Access Compliance Report

Public Rights-of-Way

Intersection ID: 10019990	Main Street: ARMORY_DR	Cross Street: N/A	Location: NE
ADA ID: 177C71DA3777	Ramp Type: Perp	Initial Pass/Fail: Fail	Overall Compliance: No
			Severity Score: 33.75

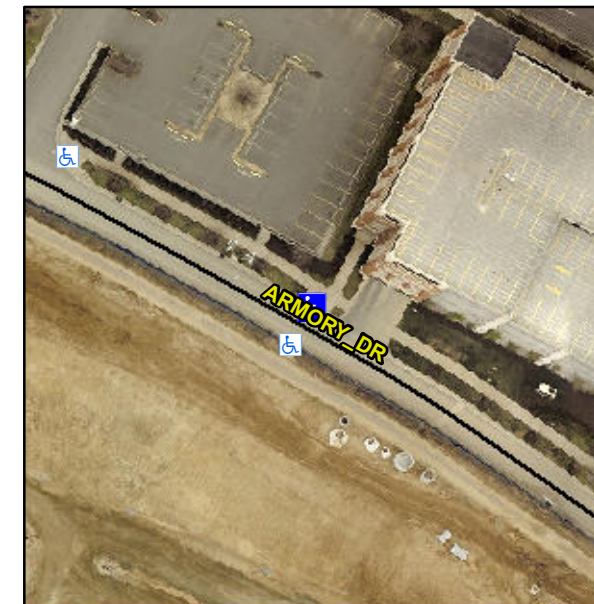
Not Found, R304.5.1, R304.2.2, R304.5.3

Compliance	Description	Data	Compliance	Description	Data
N/A	Ramp Length (in)	95.0	No	Ramp Slope (%)	8.6
No	Ramp Width (in)	46.5	No	Ramp XSlope (%)	6.8
N/A	Flare Type LT	N/A	N/A	Flare Type RT	N/A
N/A	Flare Slope LT (%)	N/A	N/A	Flare Slope RT (%)	N/A
N/A	Flare Traversable LT?	N/A	N/A	Flare Traversable RT?	N/A
N/A	Landing Length (in)	N/A	N/A	DWS Provided?	N/A
N/A	Landing Width (in)	N/A	N/A	DWS Contrast?	N/A
N/A	Landing Slope (%)	N/A	N/A	DWS Length (in)	N/A
N/A	Landing X Slope (%)	N/A	N/A	DWS Full Width?	N/A
N/A	Landing Curb? (Y/N)	N/A	N/A	DWS Offset (in)	N/A
N/A	Shared Landing?	N/A			
N/A	Gutter Ponding?	N/A	N/A	Gutter Slope (%)	N/A
N/A	Gutter Lip Ht (in)	N/A	N/A	Gutter X Slope (%)	N/A
N/A	Painted X Walk1?	No	N/A	Painted X Walk2?	N/A
	X Walk 1 Direction	To SW		X Walk 2 Direction	N/A
N/A	X Walk 1 Width (in)	N/A	N/A	X Walk 2 Width (in)	N/A
	X Walk 1 Slope (%)	1.3		X Walk 2 Slope (%)	N/A
	X Walk 1 X Slope (%)	3.0		X Walk 2 X Slope (%)	N/A

Remove & Replace Entire Ramp.
